| Change Number M-45-98-03 | Federal Facility Agreement and Consent Order Change Control Form Do not use blue ink. Type or print using black ink. | Date January 22, 2001 |
| Change Title Agreement Commitments Regarding Initial Single-Shell Tank Waste Management Area (WMA) Corrective Actions, Vadose Zone and Groundwater Characterization, Assessment, and the Integration of Vadose Zone and Groundwater Activities at specified Associated Sites. | | |

Comments and Responses to the Tentative Agreement Regarding:

(CHANGE REQUEST M-45-98-03)

Initial Single-Shell Tank Waste Management Areas and Associated Sites.

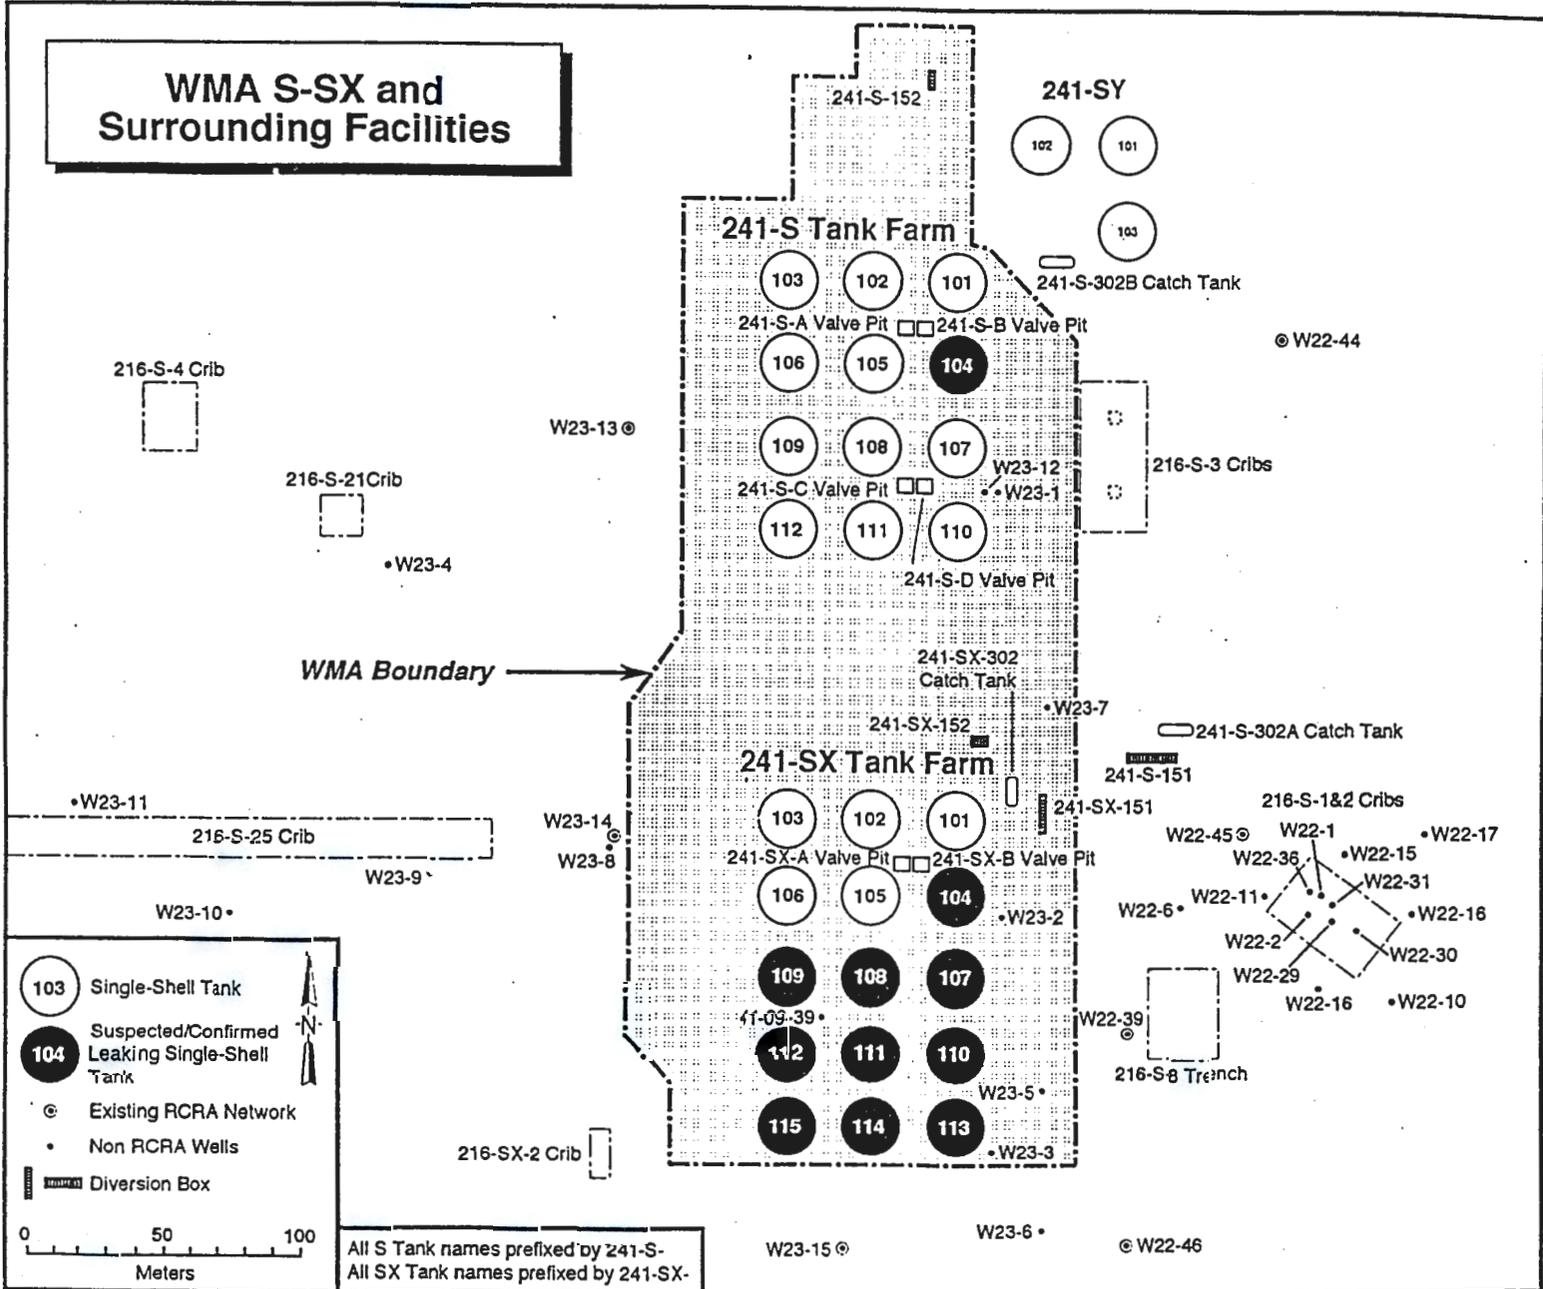
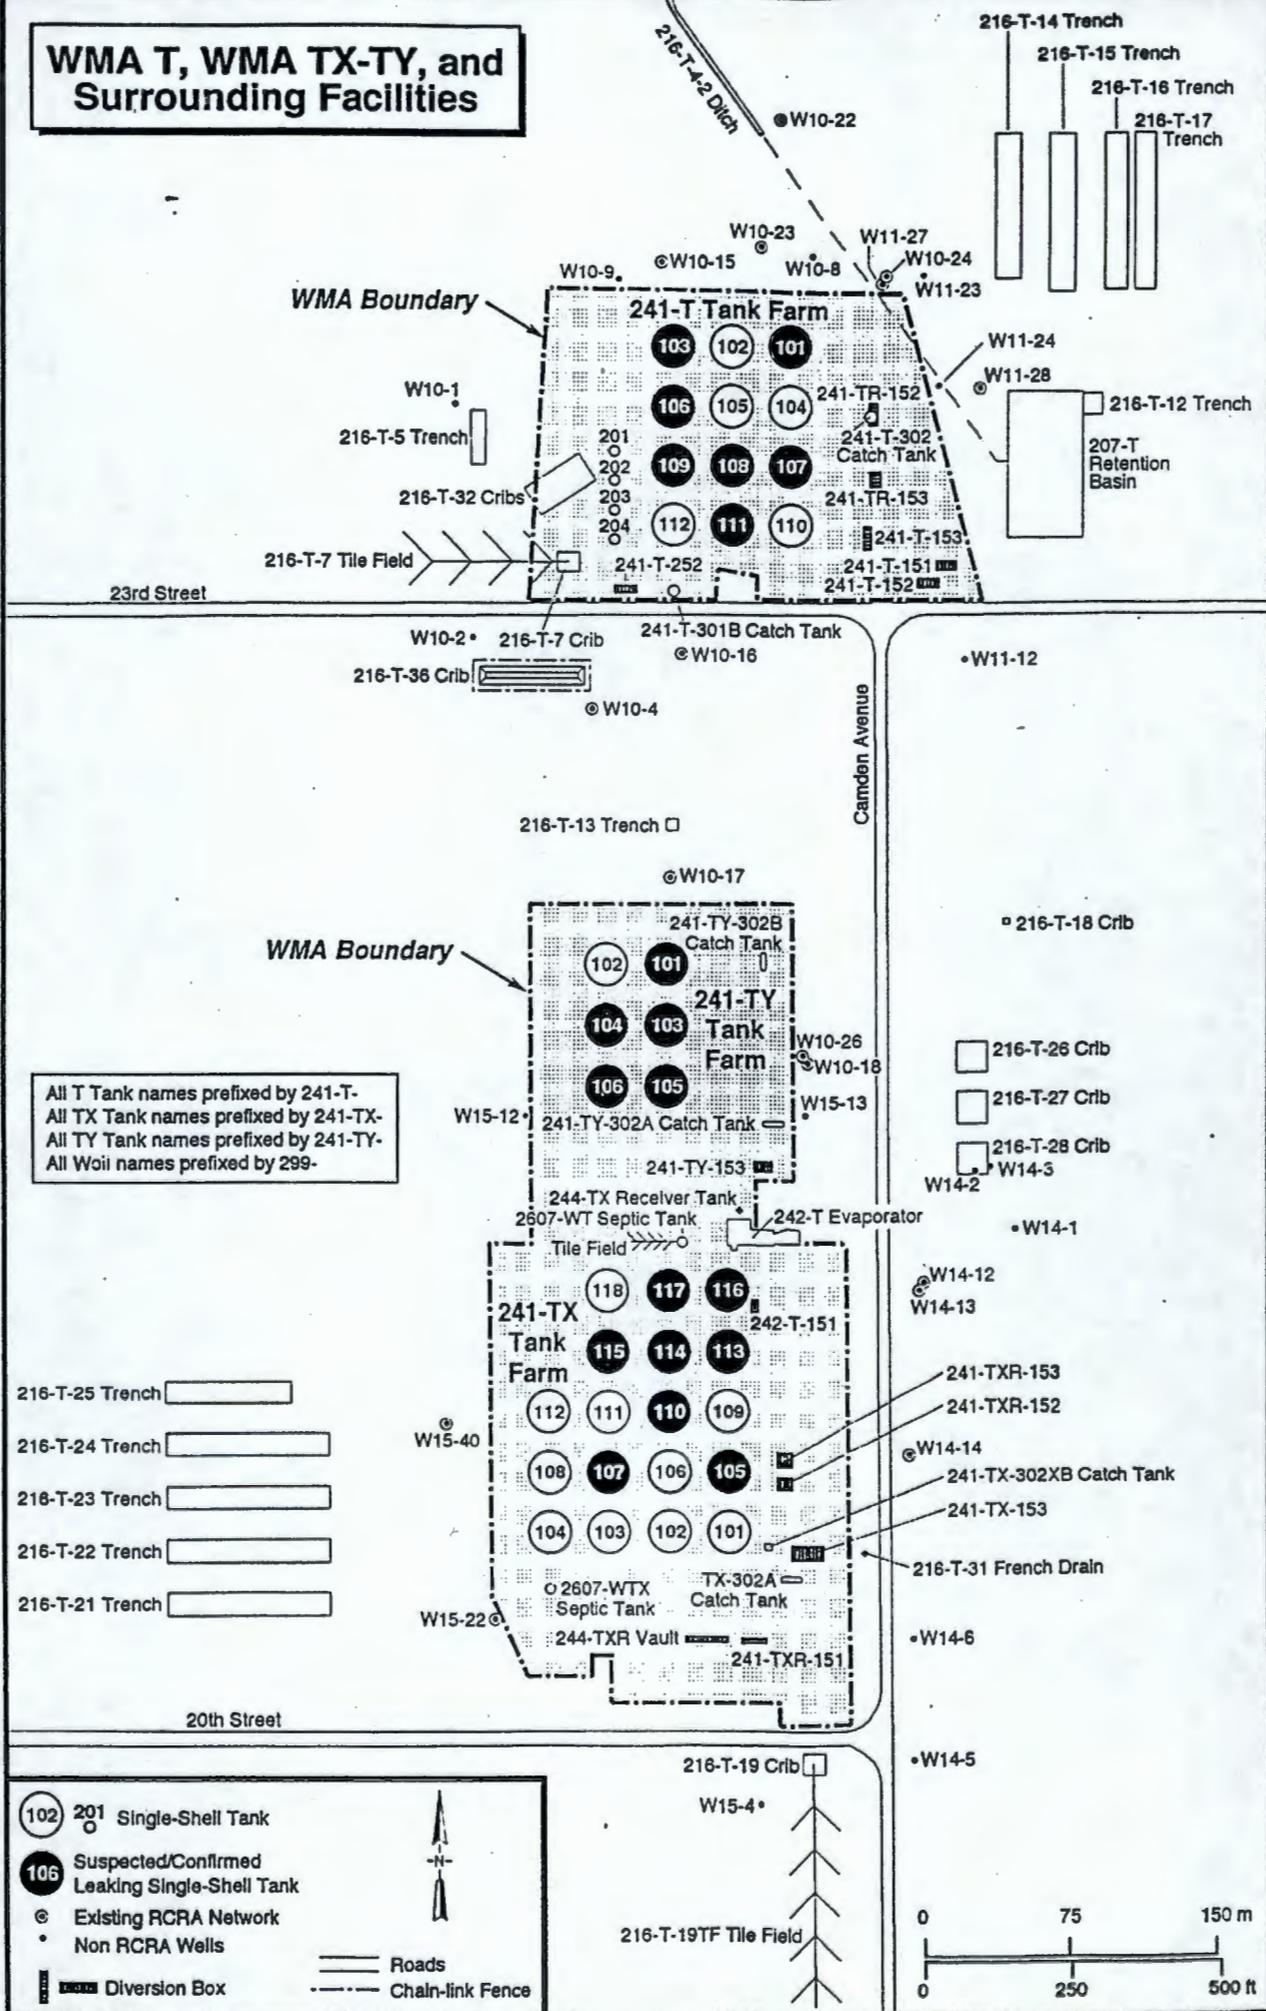
| <p>Alyssa Huckaby, Comment #38</p> | <p>Comments requesting clarifying revision of language at Change Request Attachment 1 identifying tank waste units and ER sites. Response: The following footnote has been added regarding SSTs, diversion boxes, catch tanks, and receiving vaults: "These tanks and ancillary facilities are part of the SST RCRA treatment, storage, and disposal system."</p> |
| <p>Alyssa Huckaby, Comment #39</p> | <p>Comments requesting clarifying revision of language at Change Request Attachment 1 so as to identify unplanned release sites (UPRs). Response: The UPR designation numbers will be added to the table. However, consistent with the rest of the table, a more detailed description of the UPRs will not be added. The UPR designation numbers are unique and are tracked in the Hanford Waste Information Data System (WIDS). Information on the location and nature of the releases can be found there.</p> |

**Utilization of the HWMA and RCRA Corrective Action Processes for
SST WMA and Associated Site Groundwater/Vadose Zone Decision
Making in Coordination with SST Tank Farm Closure Under
Agreement Milestone M-45.**

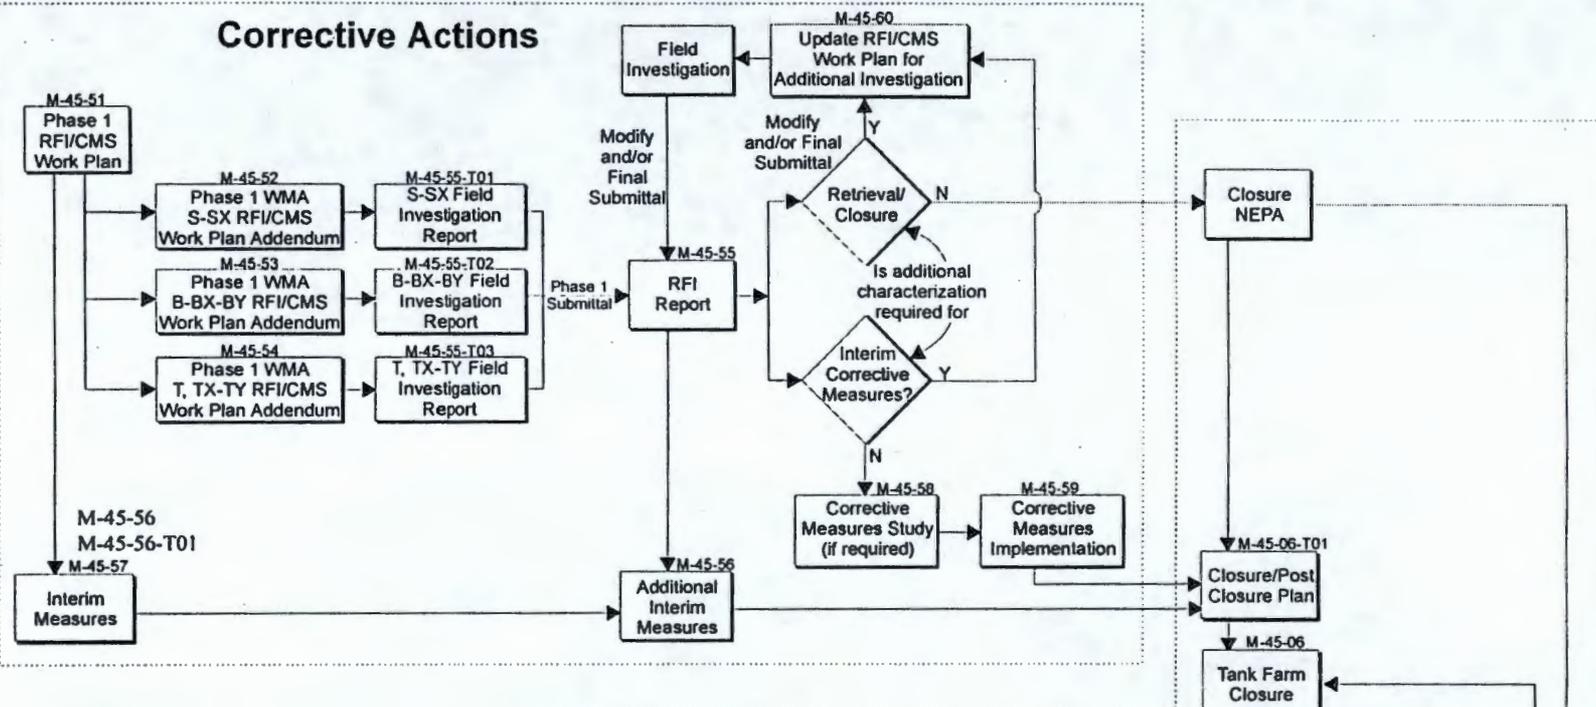
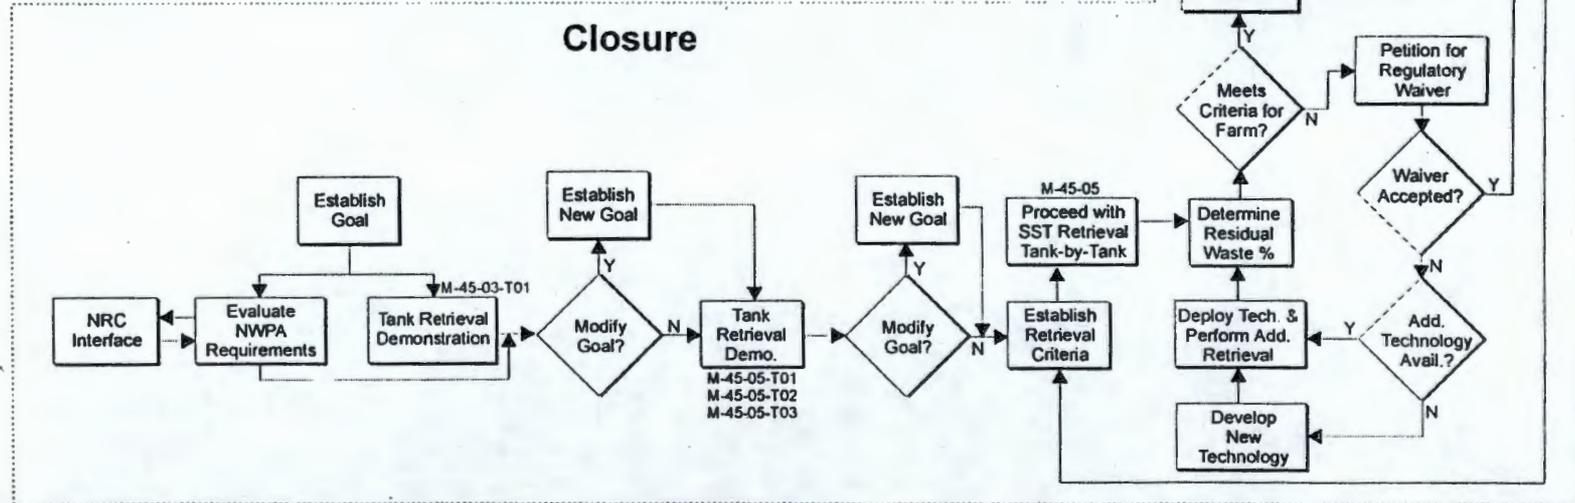
| <p>Alyssa Huckaby, Comment #29</p> | <p>Comments proposing modification of Change Request Attachment 2 depicting HWMA and RCRA corrective action decision processes in coordination with tank farm closure processes under TPA milestone M-45-00.</p> <p>Response: Milestones M-45-56 and M-45-56-T01 will be added to the "Interim Measures" box on the flow chart, joining Milestone M-45-57. Milestone M-45-55 requires submittal of an RFI report, not implementation of interim measures (the RFI report may identify interim measures, but implementation would be under M-45-56) so it was not added. Milestone M-45-56 encompasses all interim measures that have been identified or that might be identified in the future. The arrow to future "Additional Interim Measures" hopefully can convey that there may be a continuum of interim measures. A multitude of boxes could be confusing.</p> |

| <p>Alyssa Huckaby, Comments #40 and 41</p> | <p>Comments recommending revision of Change Request Attachment 2 (flow chart) interim measure milestone identifiers. Response: Milestones M-45-56 and M-45-56-T01 address implementation of both immediate interim measures and those that might be implemented later in the corrective action process. Therefore, the flowchart will be modified to add these milestones to the "Interim Measures" box. Milestone M-45-57 only addresses monitoring well cap upgrades and was completed in July 1999. Thus, it is appropriately only reflected in the near-term "Interim Measures" box.</p> |
